Bruce Freeman Rail Trail Design Task Force Recommendations Report

March 21, 2017
Board of Selectmen Meeting

Recommendations: Alternative Routes

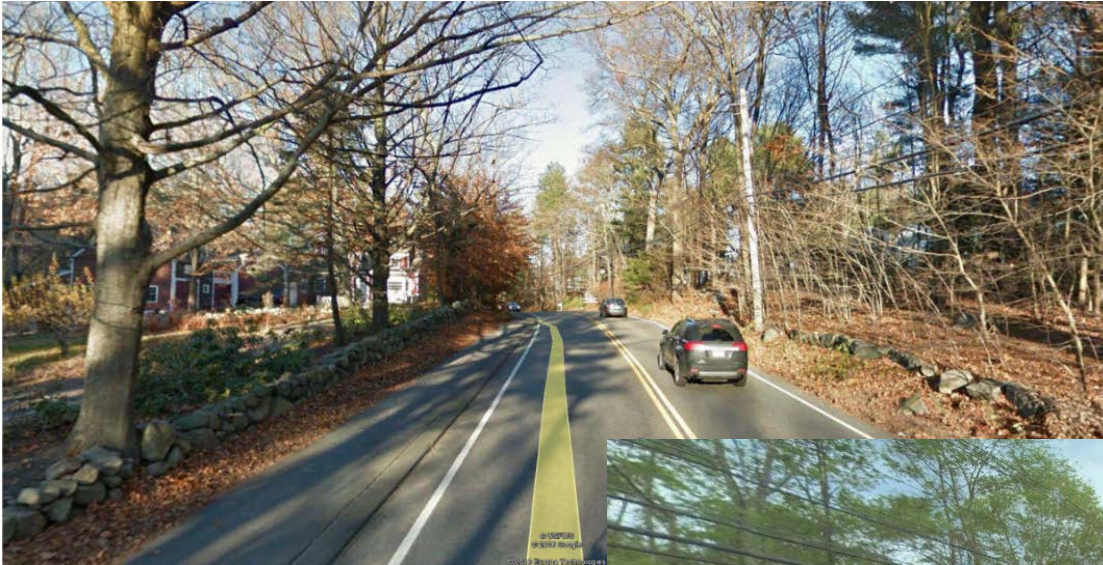
- Alternative Routes –None of the presented roadway alternative options are considered feasible
 - Infeasibility is based on limited right of way, lack of abutter support, cost, safety concerns at the roadway intersections and the numerous driveway intersections, and lack of desired trail user experience
- It is recommended that the Design Team continue to collaborate with the concerned businesses abutting the rail corridor to identify potentially more feasible alternatives

Recommendations: Standard Trail Width

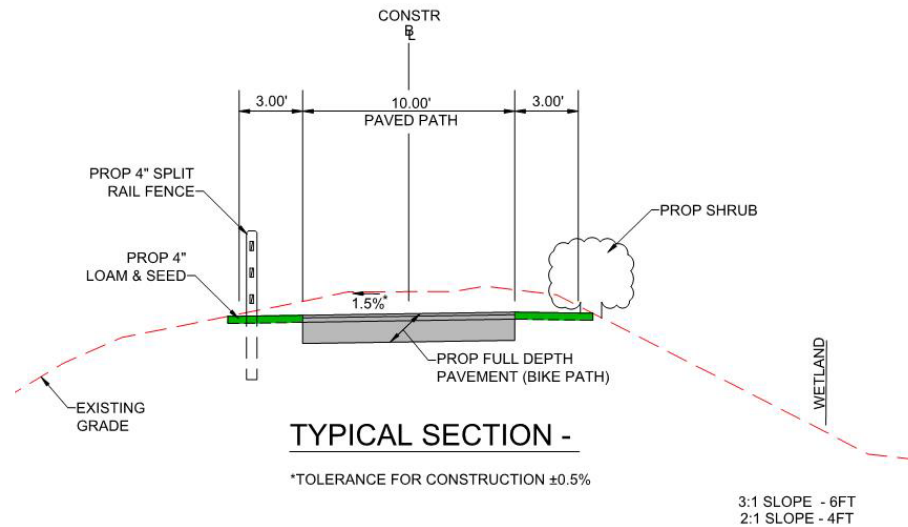
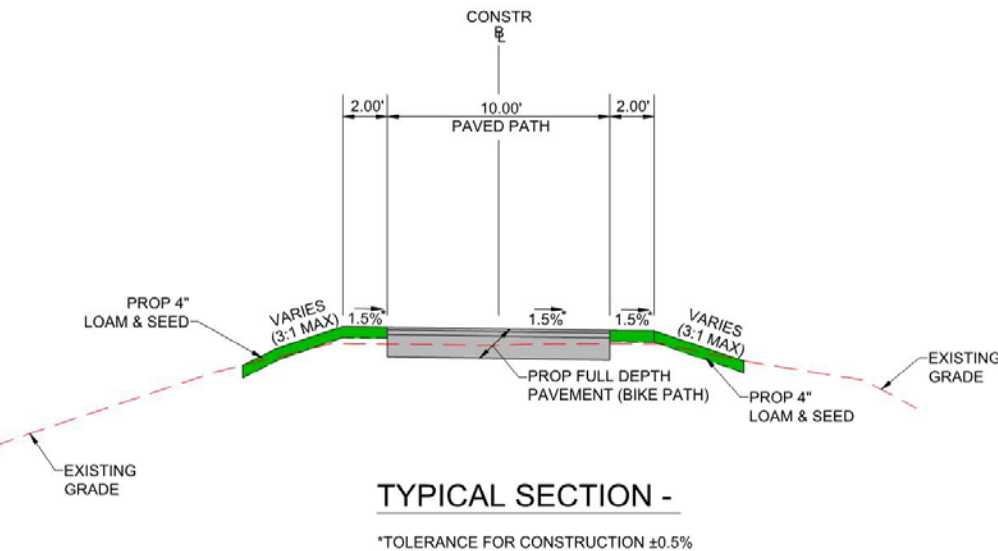
- Standard approach: 10-foot path standard with 2-3 foot shoulders (depending on the slope adjacent to the path and the need for a barrier). This represents a 14 or 16-foot wide layout

Recommendations: Treatments in Challenge Areas

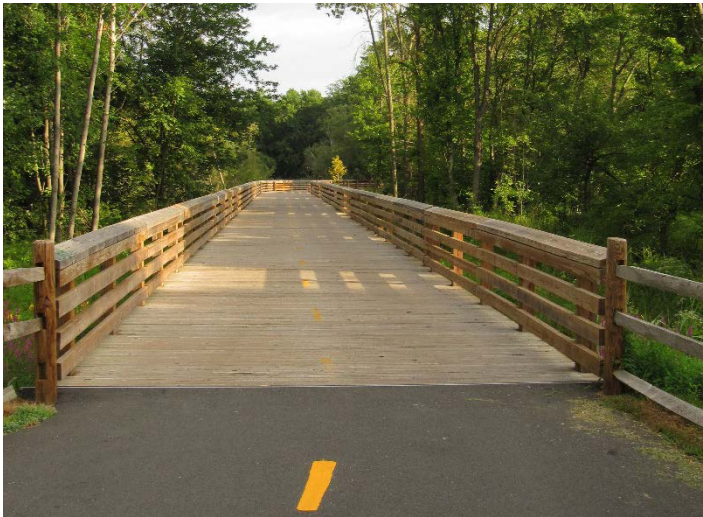
- Challenge area (#1) south of Hudson Road (650 ft): 14-foot elevated boardwalk
- Challenge area (#2) south of North Road (1200 ft): Reduced width and retaining walls. 10-foot paved path and 1-foot shoulders.
